# **A G E N D A**

## **Architectural Review Board**

**March 22, 2016**

BIBB STREET: GRAPHIC ART INSTALLATION

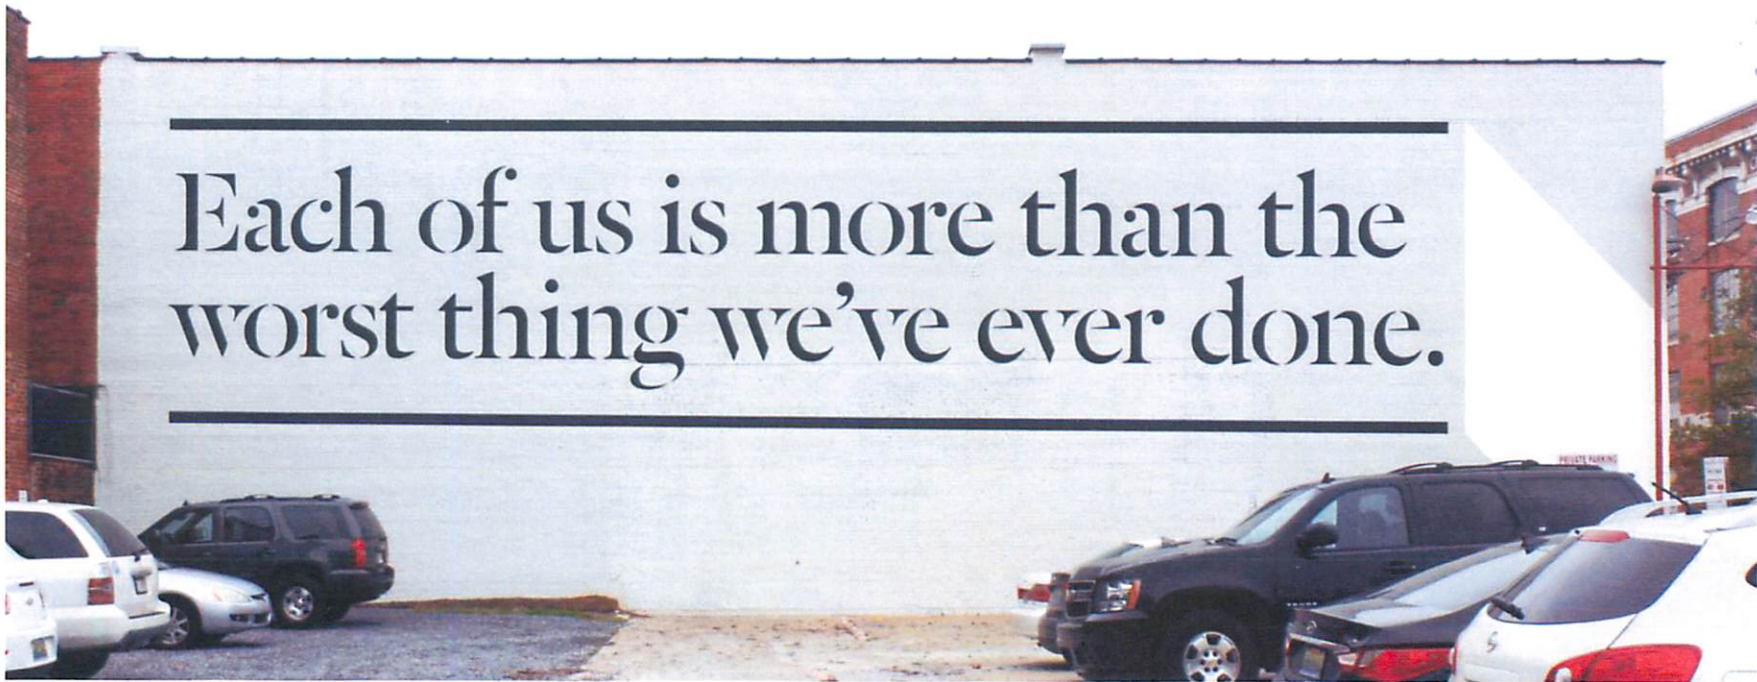
- The Board needs to determine if the proposed art installations are appropriate for a commercial historic district. SmartCode permits public art in T5 zoning.

- For consideration of treatments to historic buildings
  - The proposed art installation is on a secondary elevation that may not always be visible should the corner lot be developed;

- The wall has already been painted, application of additional paint would not likely cause additional harm to the brick surface
  - This has been a debate in several downtowns around the country (per the NAPC list serve) as to the appropriateness of art/murals on walls. Where it has been permitted, it has often been on the rear or secondary elevation of a historic building (not primary street frontage), on a non-historic building, and has been driven by a desire to energize a budding art movement in downtowns undergoing revitalization efforts. One person suggested the Preservation should try to work with planning initiatives and artists, particularly if those things are not at odds with preservation practices.

- Questions that stem from the Secretary of the Interior’s Standards for Rehabilitation: Does the addition of art change or irreparably alter the historic character or material integrity of the building? Does it remove historic material or introduce conjectural historic features? Does it destroy historic materials that characterize the property? Is the proposed art reversible without impairing the historic property?

THE SOLDIER  
AT  
UNION STATION

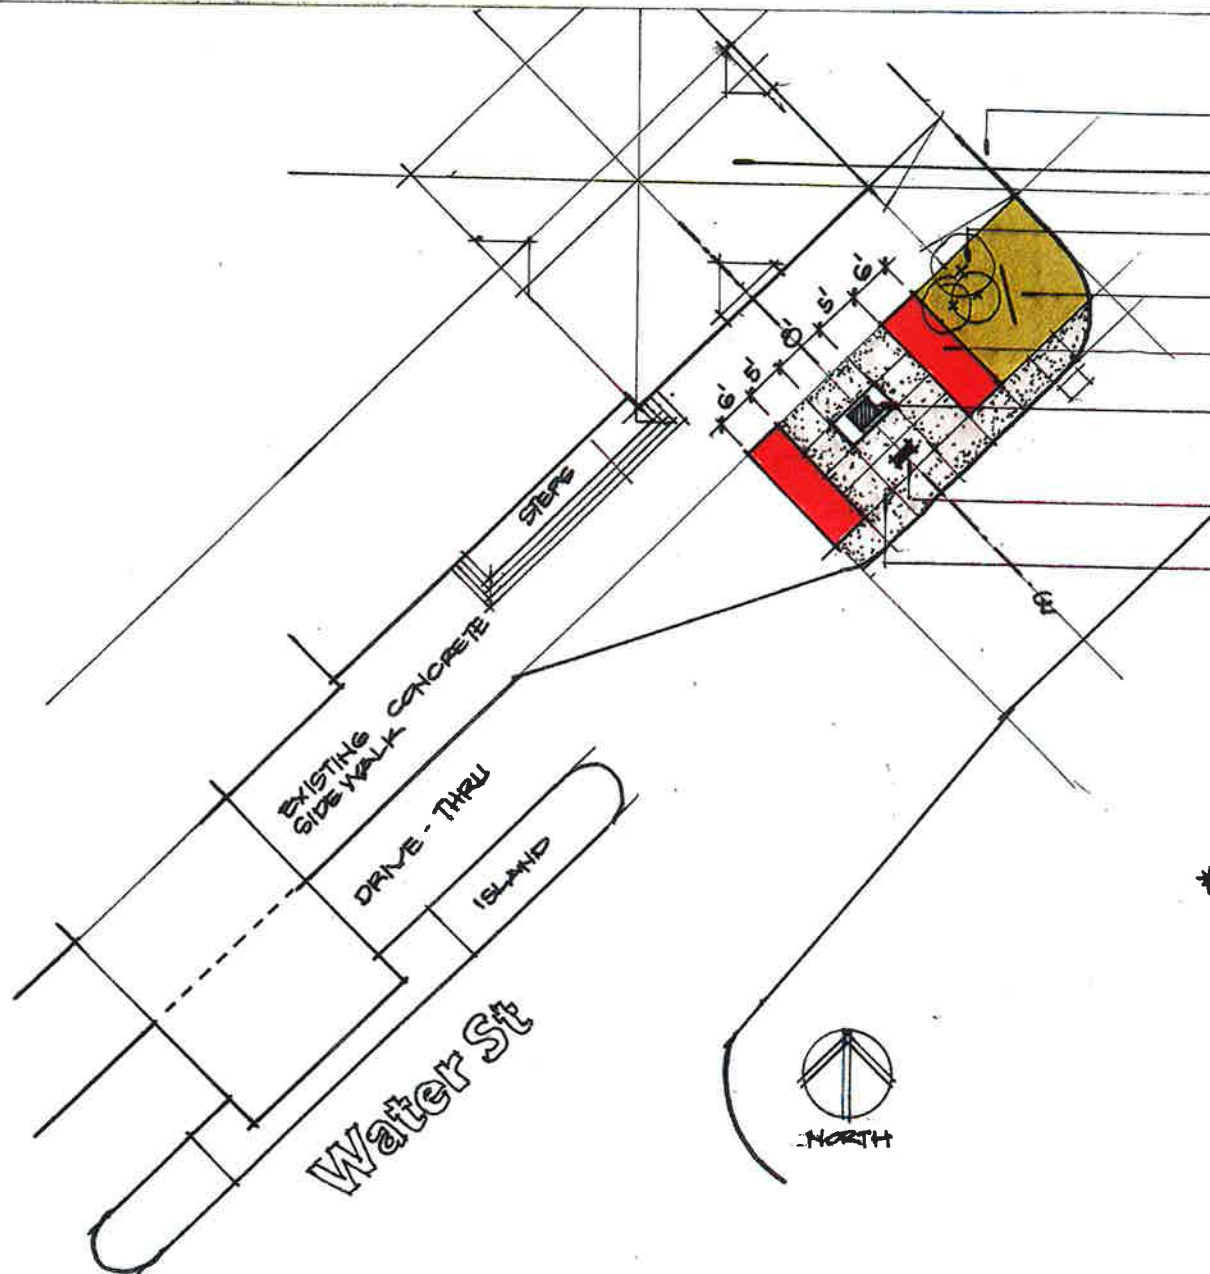
- The Alabama Historical Commission holds an easement on the property, and will also be reviewing the proposed installation of the statue in this location.
- Questions that stem from the Secretary of the Interior's Standards for Rehabilitation: Does the addition of art change or irreparably alter the historic character or material integrity of the building? Does it remove historic material or introduce conjectural historic features? Does it destroy historic materials that characterize the property? Is the proposed art reversible without impairing the historic property?

Proposal to the Montgomery Architectural Review Board  
Chimney Demolition  
George & Alissa Marodis  
25 S. Capitol Pkwy

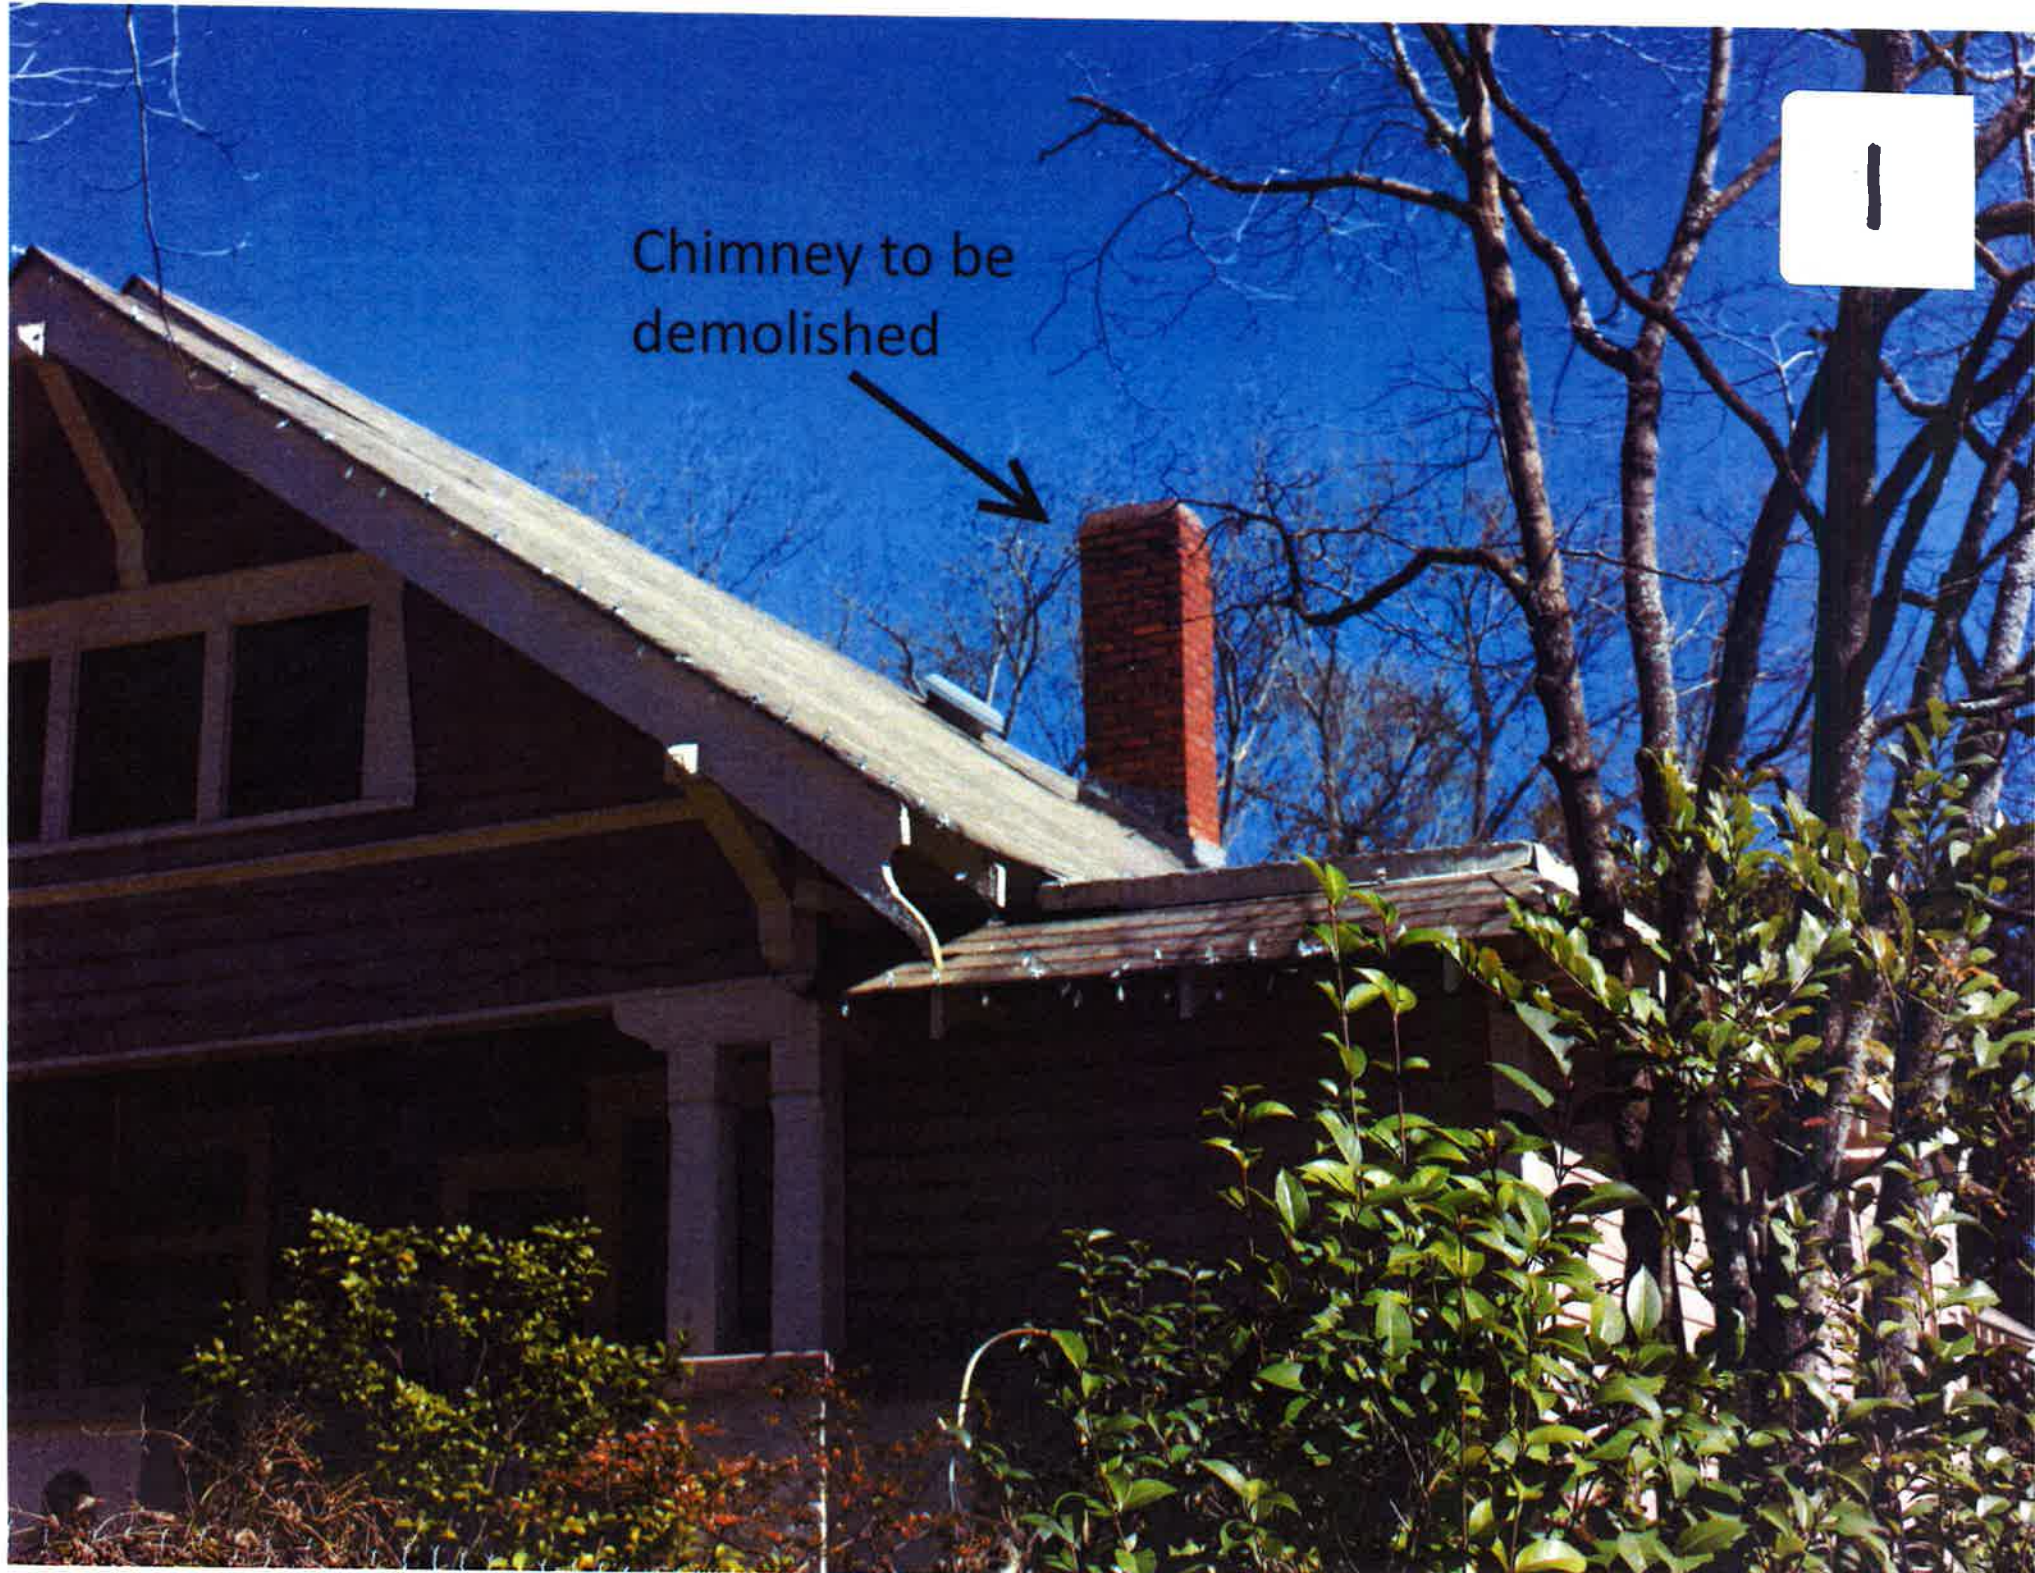
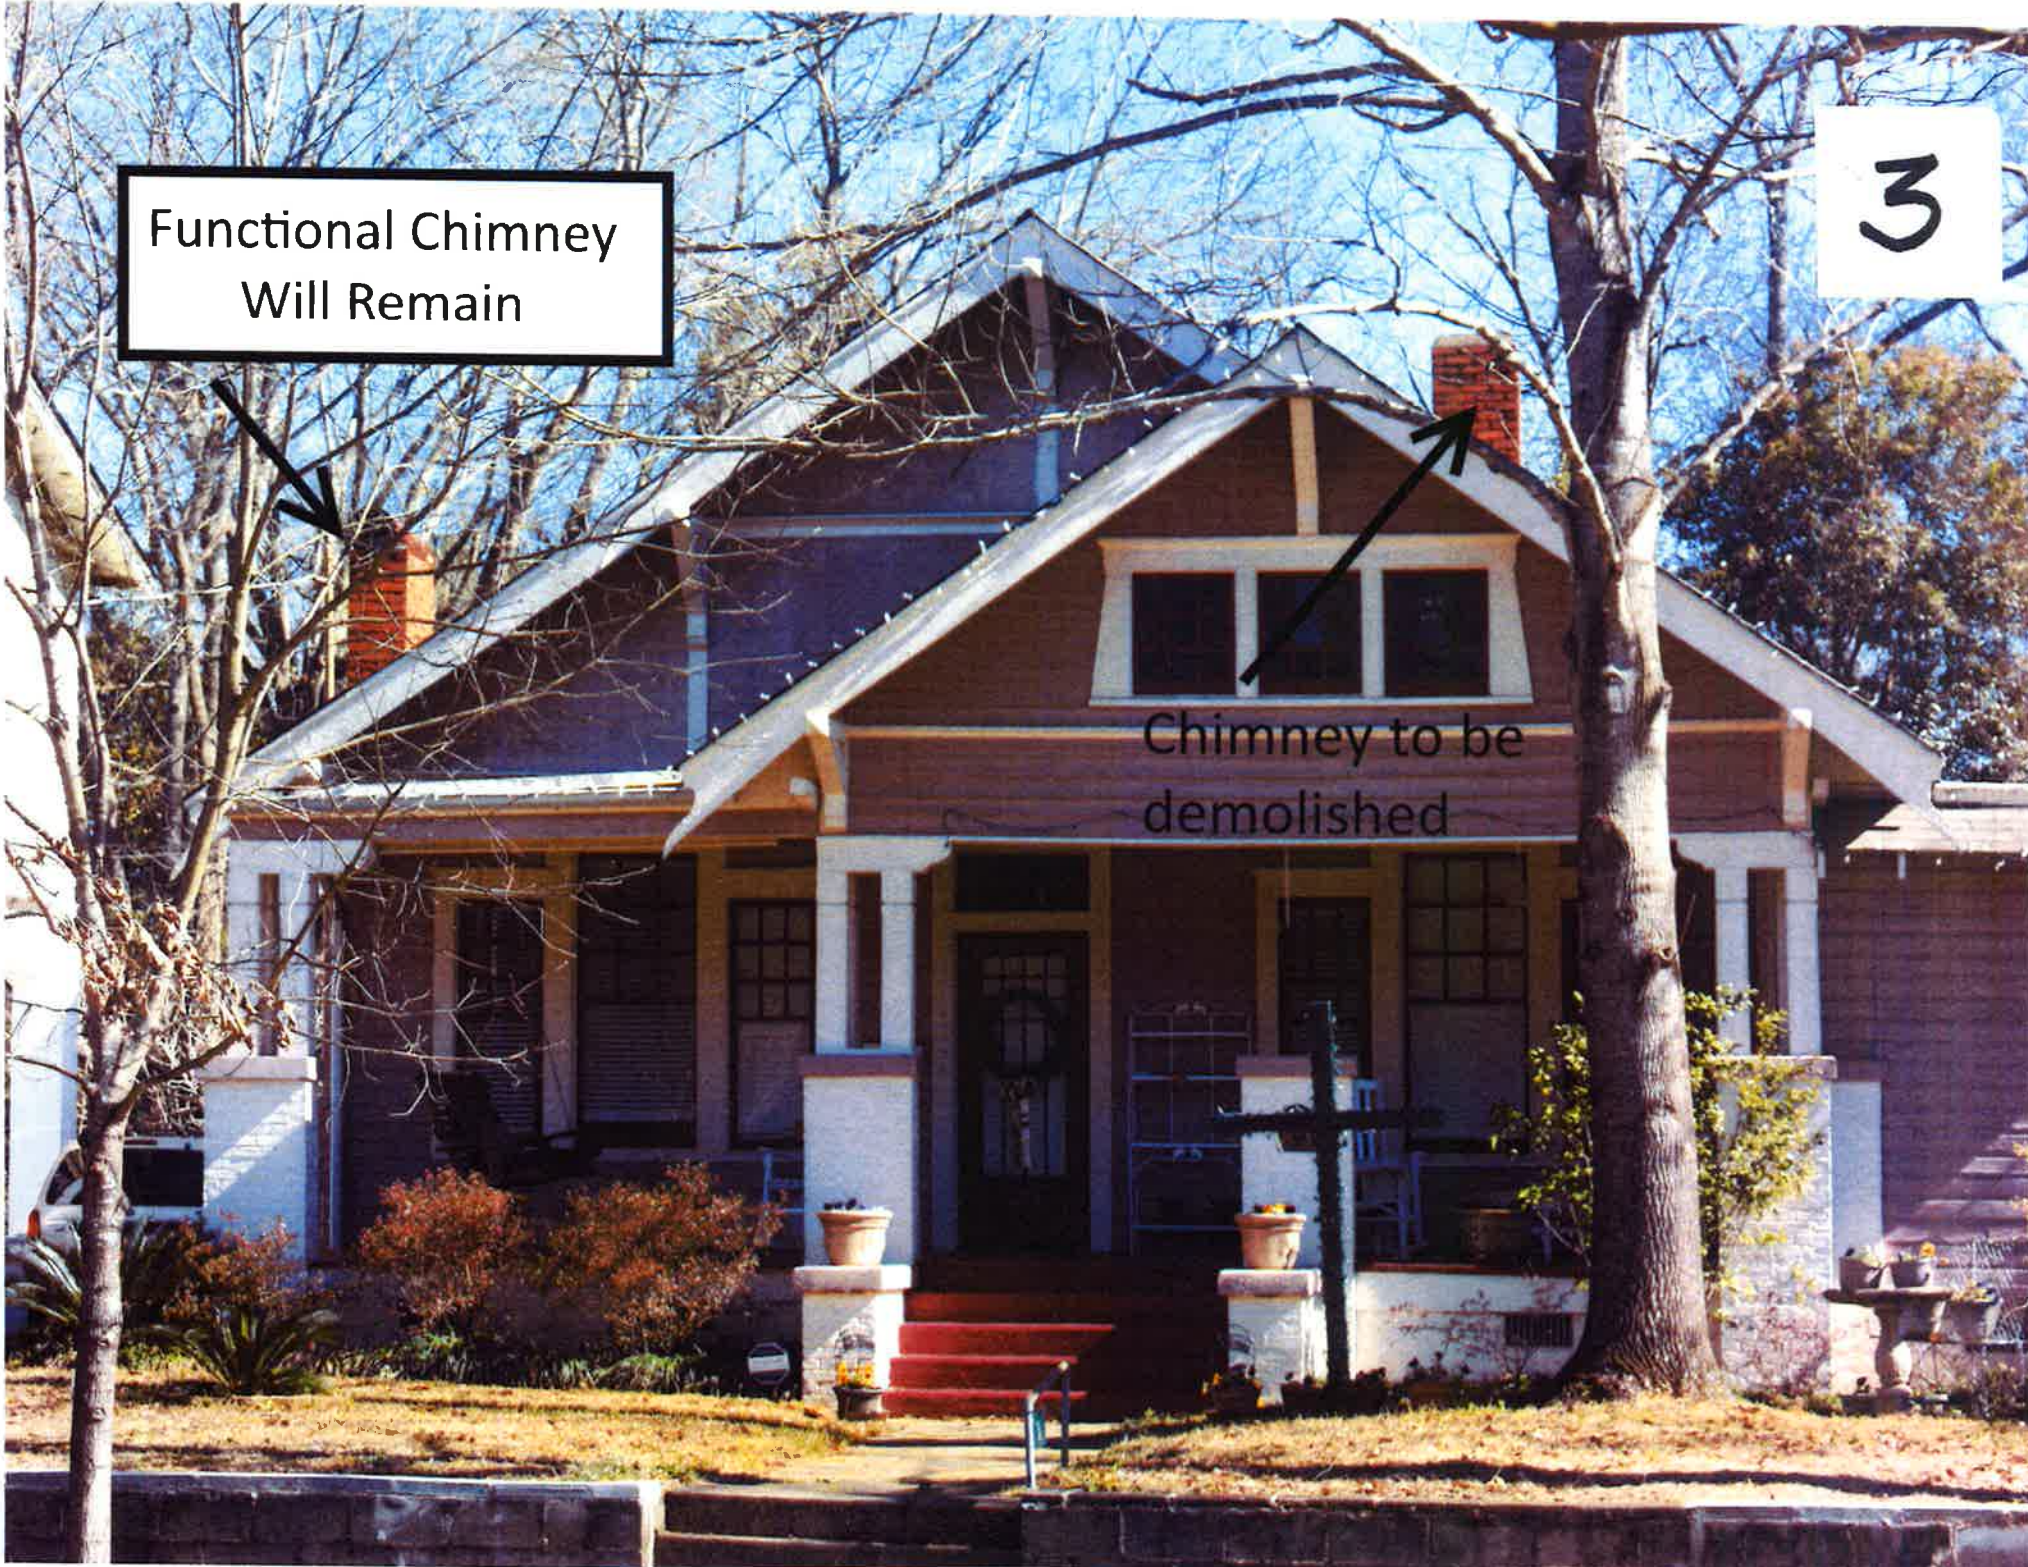
- The question the Board has grappled with on chimney removal requests is whether or not the chimney is a character defining feature on the house? Is it an important architectural element to the building? Or is its location and design such that if it wasn't there, there would not be a negative visual impact on the structure?
- Looking straight on at the house, the chimney is not visible.

**ReliaBilt Craftsman Glass Insulating Core 6-Lite Left-Hand Inswing Primed Steel Prehung Entry Door (Common: 36-in x 80-in; Actual: 37.5-in x 81.75-in)**

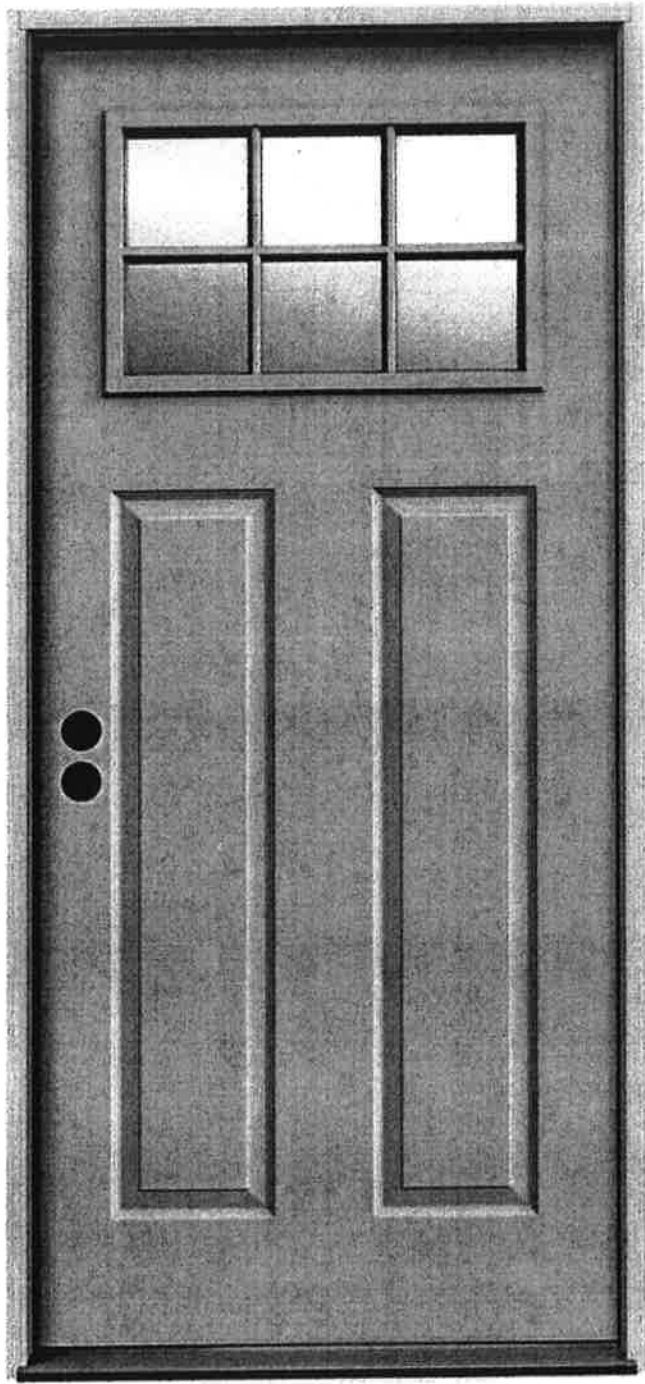
- The Board has approved steel doors on rear elevations and outbuildings
- The ONLY issue before the Board is converting a window to a door, and not the use of the building.

1215 WOODWARD AVE.  
House

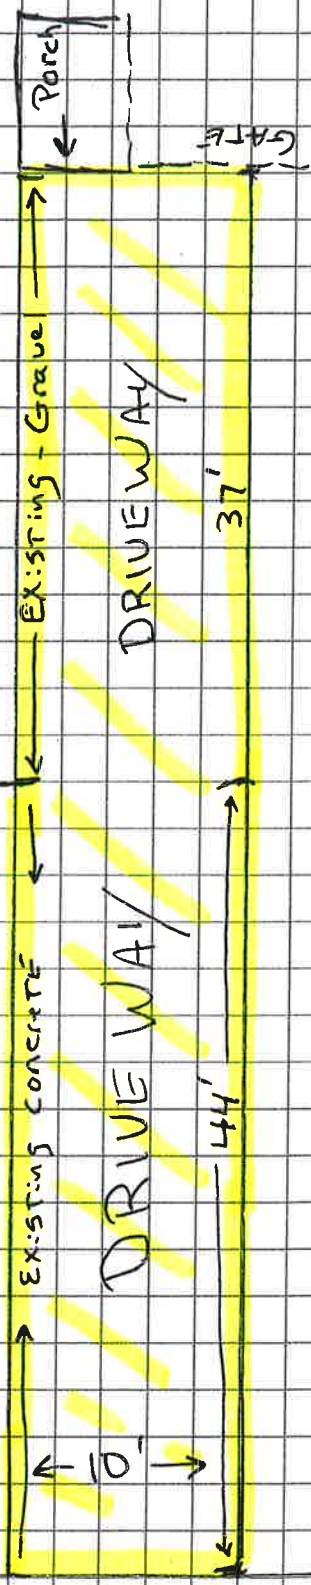
- The proposal is only introducing a new surface area to be covered between the house and the outbuilding, the other areas already have some paving or hard material.
- As a side note, the ARB approved the work on this house (opening porch, adding pergola on the front), and the Historic Preservation Commission recognized it as a recent "Restoration of the Month".
